DOCUMENT 00 90 00
ADDENDUM

ADDENDUM No.: 1

RE: LOGAN HS HVAC UPGRADES
SCHOOL DISTRICT OF LA CROSSE
1500 RANGER DRIVE
LA CROSSE, WI 54603
PROJECT NO. 22057

3 HVAC SECOND FLOOR REMOVAL PLAN - BUILT-UP AHU-8
1/4" = 1'-0"

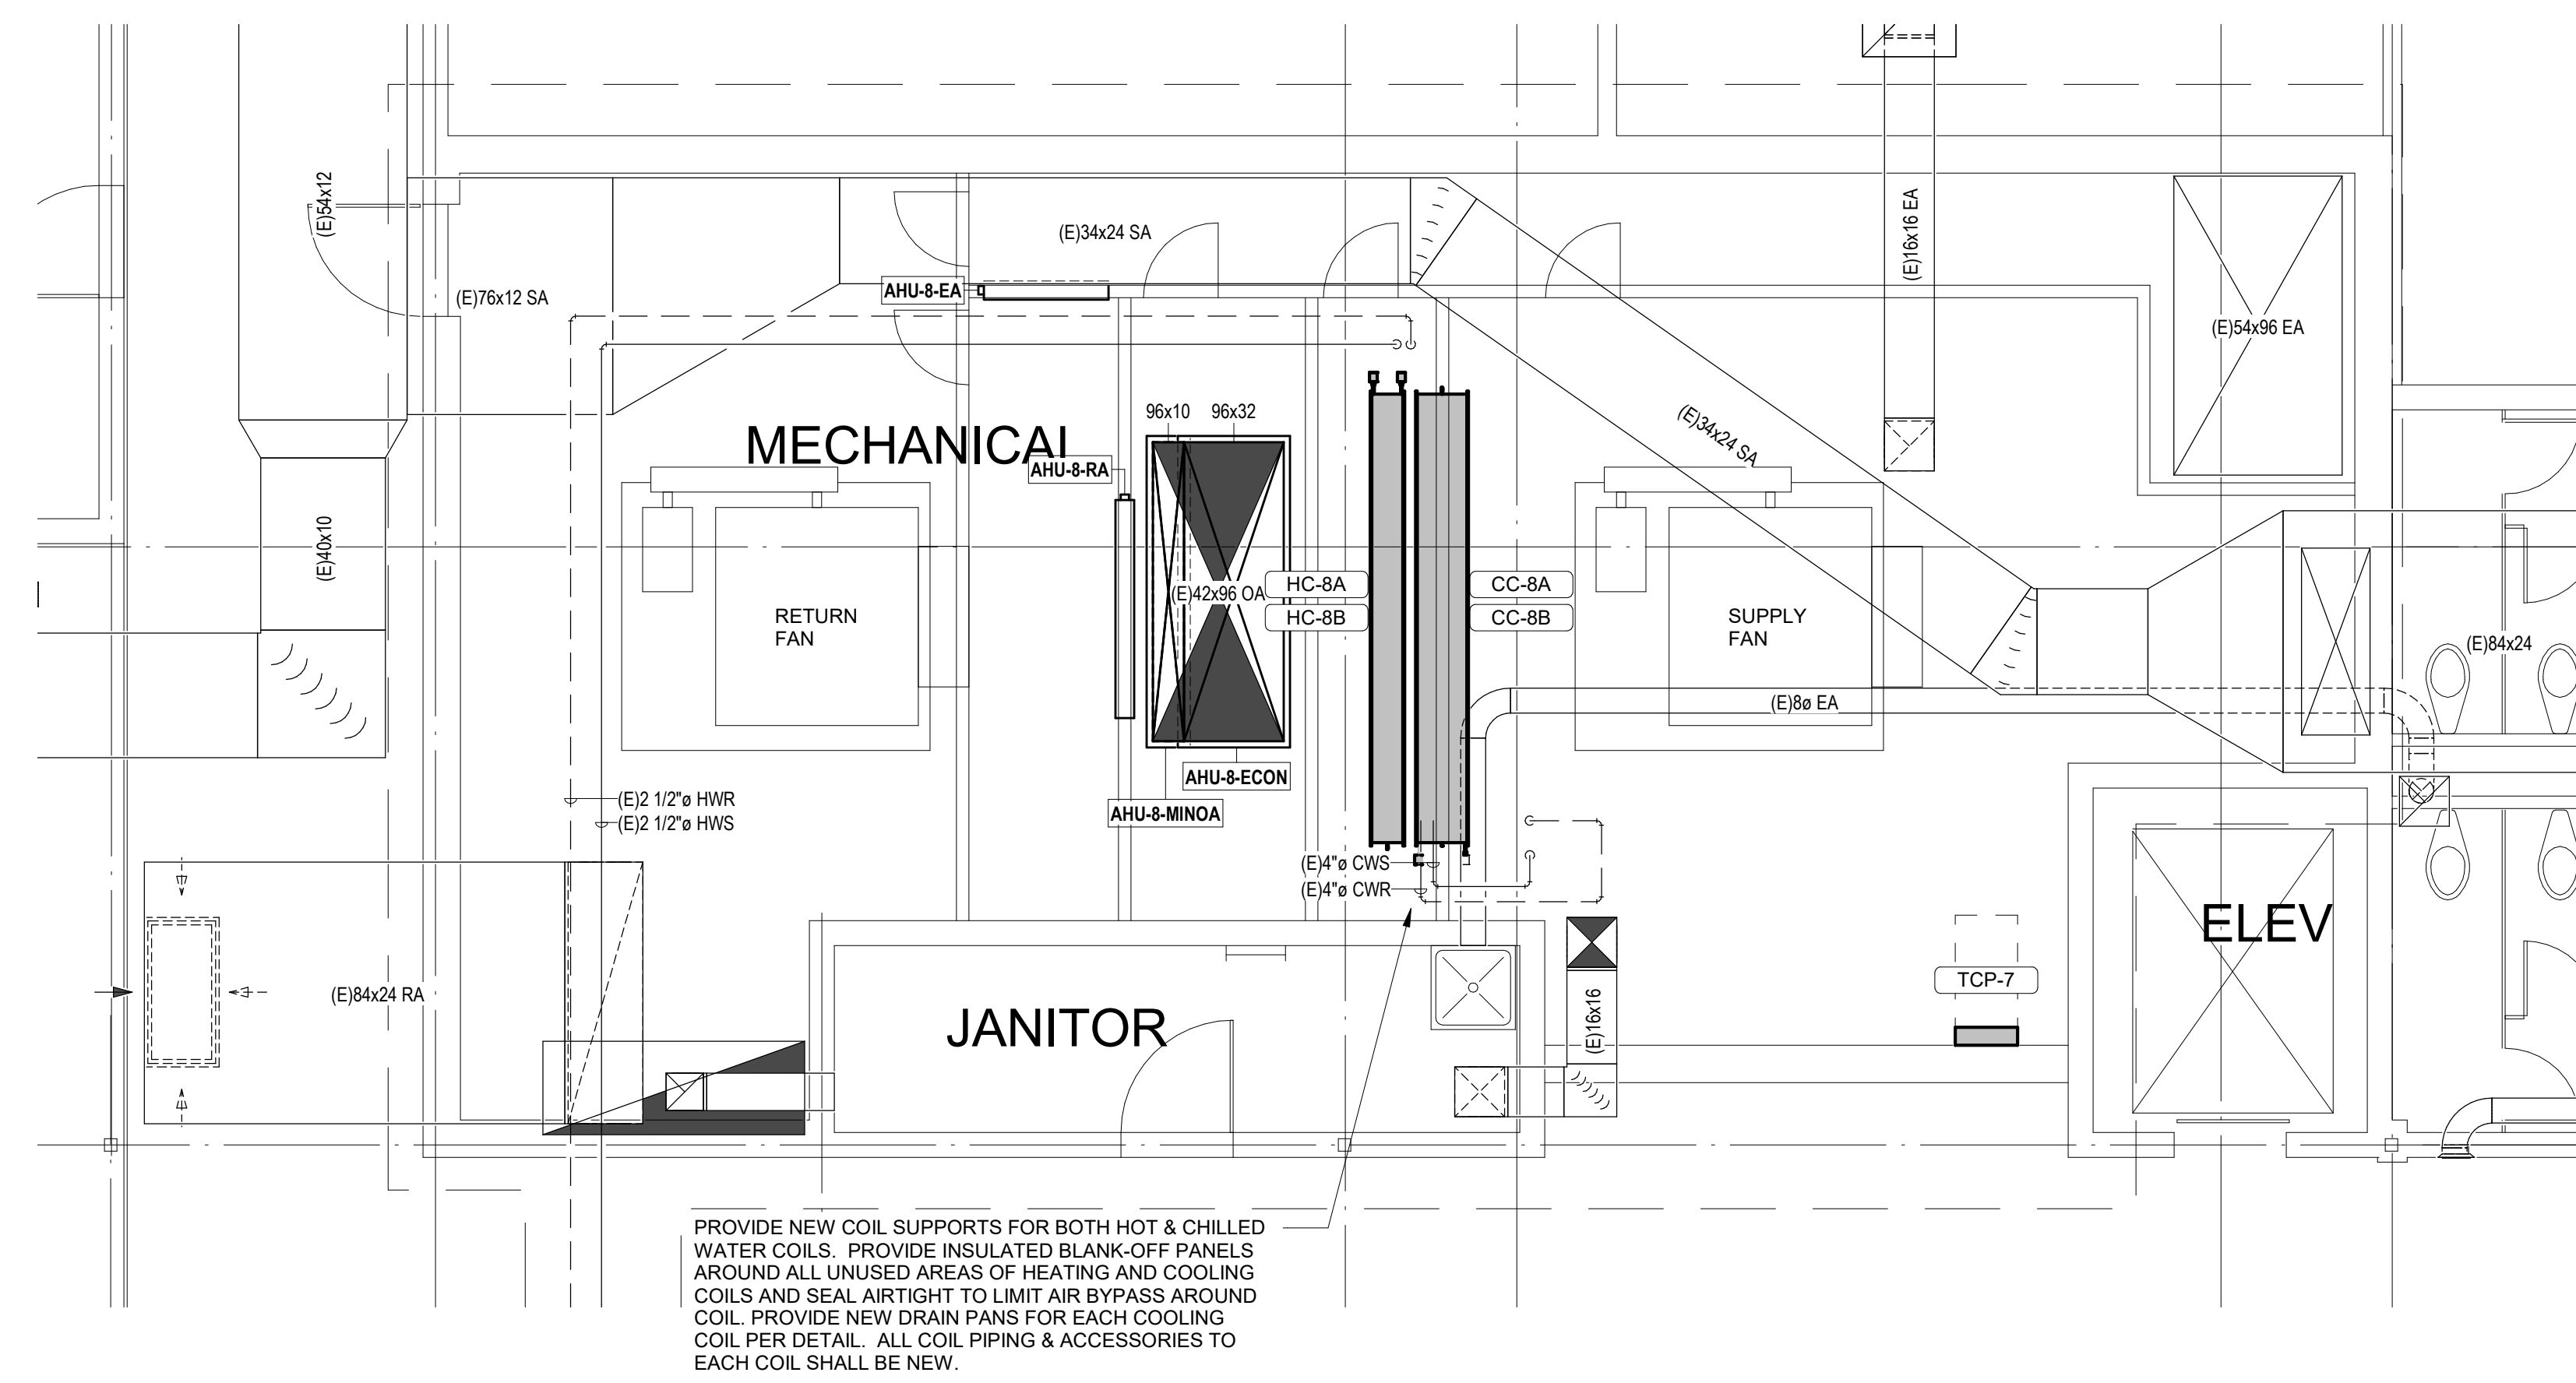
5. Sheet M201 ENLARGED PLANS 30"x42"
 - a. See the revised sheet included in this addendum. Disregard the previous version.
 - b. Added motorized dampers (E)PF-1 and (E)PF-2 to floor plan.
6. Sheet M202 ENLARGED PLANS 30"x42"
 - a. See the revised sheet included in this addendum. Disregard the previous version.
 - b. Modified routing of new 3" HWS/HWR piping to come through the floor of the 1995 Boiler Room.
7. Sheet M601 HVAC SCHEDULES 30"x42"
 - a. See the revised sheet included in this addendum. Disregard the previous version.
 - b. Added (E)PF-1 and (E)PF-2 to Motorized Damper Schedule.
8. Sheet E103 ELEC. REMOVAL AND REMODEL PLAN 30"x42"
 - a. See the revised sheet included in this addendum. Disregard the previous version.
 - b. Add motors HWP-1 and HWP-2 to Motor Schedule
 - c. Add Note #4 to motor schedule remarks.
 - d. Revised remarks column in motor schedule.
